REQUEST

Current Zoning: NC (neighborhood center)
Proposed Zoning: MUDD-O (mixed use development, optional)

Approximately 0.94 acres located at the southeast intersection of Commonwealth Avenue and The Plaza, north of East Independence Boulevard.

The petition proposes to allow for the redevelopment of a parcel utilized as surface parking with multi-family residential and commercial uses. Golden Triangle #7 – Commonwealth, LLC, Levine Properties, Inc. Levine Properties, Inc. Brittany Lins and Collin Brown, Alexander Ricks, PLLC Meeting is required and has been held. Report available online. Number of people attending the Community Meeting: 26

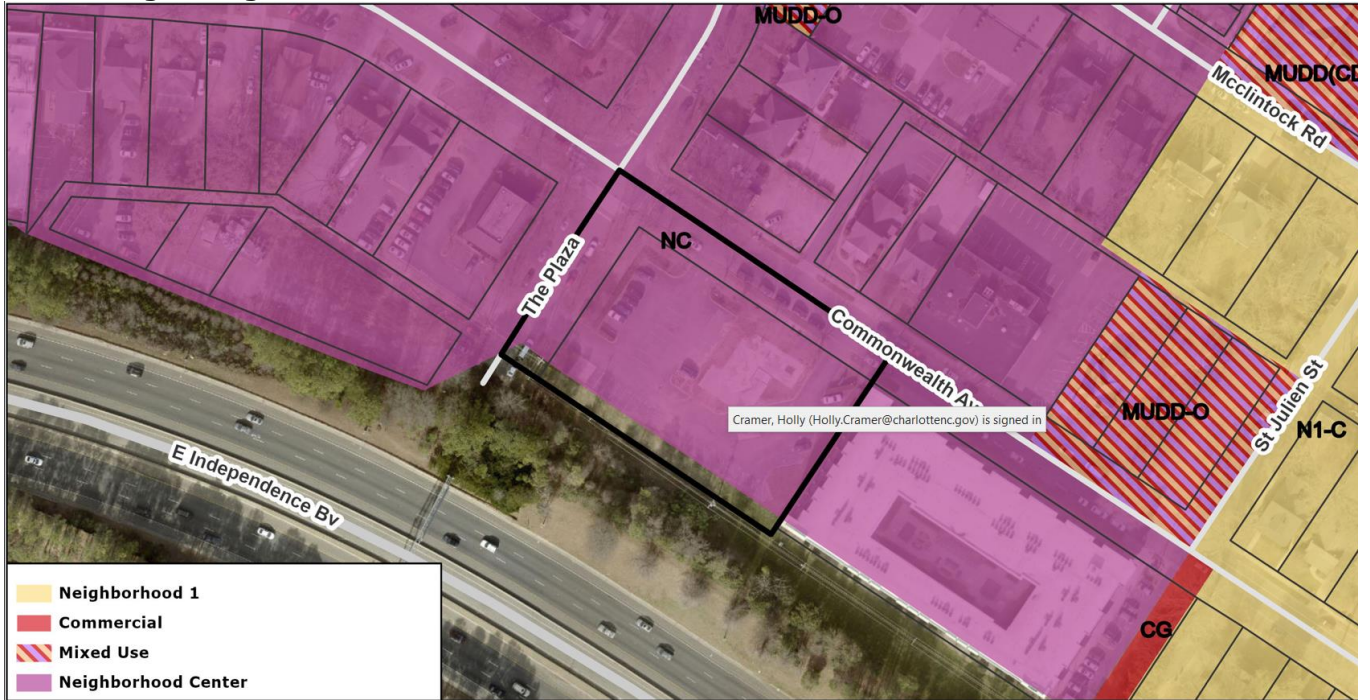
- Requests an optional provision to exceed the maximum height provisions for the MUDD district.
- Requests a maximum height of 126' ~~150'~~. Commits to provide community benefits consistent with the bonus provisions set forth in UDO section 16.3 for any building height beyond 80'.

2. ~~The back of curb sidewalk shown is not acceptable to CDOT, remove from plan. Based on the context of the street CDOT can consider a consider a local office/commercial wide with parallel parking and curb bumpouts per CLDSM U-05, with amenity zone instead of planting strip. In addition, remove proposed park — park not allowed in right-of-way.~~ **Addressed**

4. ~~Reduce the maximum height to provide contextual sensitivity to the surrounding building forms.~~ **Addressed**

5. ~~Revise note 7 under the Design Guidelines to commit to community benefits to achieve building height above 80'. Commit to specific community benefits.~~ **Addressed**
 6. ~~Identify building envelopes(s) rather than one development area.~~ **Rescinded**
 7. ~~Remove optional provision allowing for a drive through.~~ **Rescinded**
-

1. Show required right-of-way trees. **Addressed**
